# Technical Service Information

## FORD E4OD NO 2-3 UP SHIFT

Figure 2

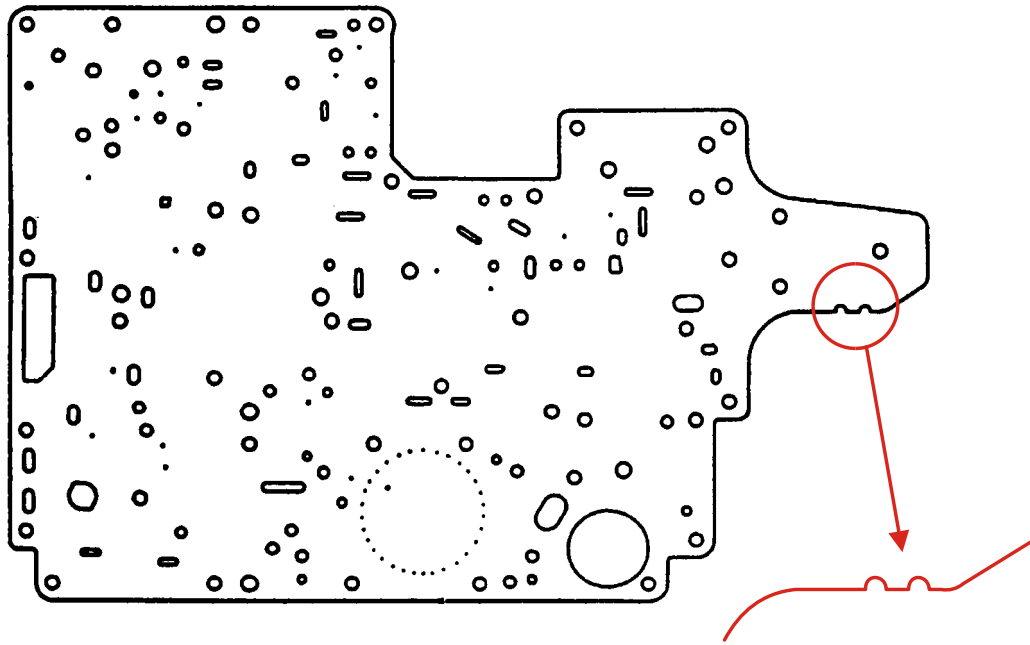
**CAUSE:** The cause may be, cross leakage between the spacer plate and valve body and/or transmission case, created by distortion of the spacer plate.

**CORRECTION:** Remove the valve body spacer plate, and inspect for spacer plate distortion in the area shown in Figure 2. Both valve body gaskets must be removed to see the distortion. If the spacer plate is distorted, replace it with OEM part number F4TZ-7A008-A, and re-install using new valve body gaskets. Refer to Figure 3 for the new spacer plate I.D.
